RE: San Diego Gas & Electric Company's Response to Notice of Violation – NOV_CAD_SDGE_ATJ_20250325_0829

Violation 1. Energy Safety observed that in implementing 2024 WMP initiative 8.1.2.1 - Covered Conductor Installation (WMP.455), SDG&E failed to complete Covered Conductor Installation on pole ID P275777, Grid Hardening ID P275777_0073-R-CC_4102 at coordinates 32.760862481866, 116.688413323077. Energy Safety considers this completeness violation to be in the Moderate risk category.

A. Violation 1 – Excessively Loose Down Guy Wire Resulting in Primary Fiberglass Strain Insulator to Rest on Crossarm Suspension Dead-End Insulator.

Figure 4 – Image obtained on 3/25/2025 by OEIS and provided in NOV report showing CIP transferred to new facility, overlay with directionality of force induced by CIP facility, postulated deflection of structure caused by CIP attachment, and subject hardware conflict (for illustration purposes only)

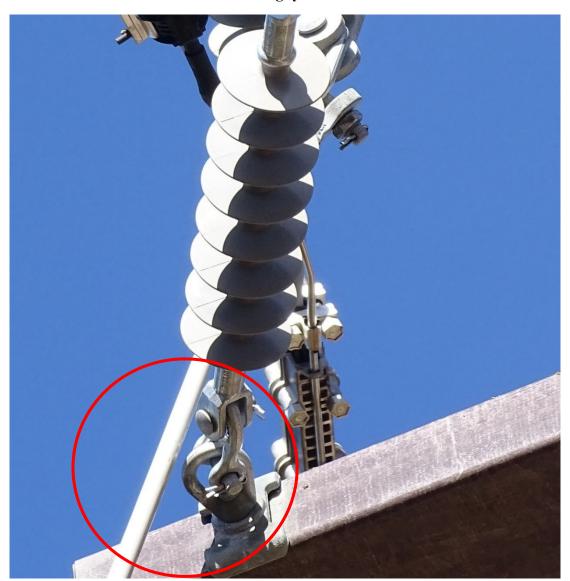
Furthermore, based on: (1) the postulated directionality of the load (i.e., force) resulting from the CIP's transfer, (2) the induced deflection observed in the structure, and (3) the resulting slack in the down guy producing identified violation, the evidence indicates that the CIP's actions were the cause of the nonconformity identified in the violation. Imagery obtained by OEIS on March 25, 2025 (Figure 4), depicts the CIP's facilities affixed to the new pole, overlaid with the aforementioned phenomena for illustrative purposes.
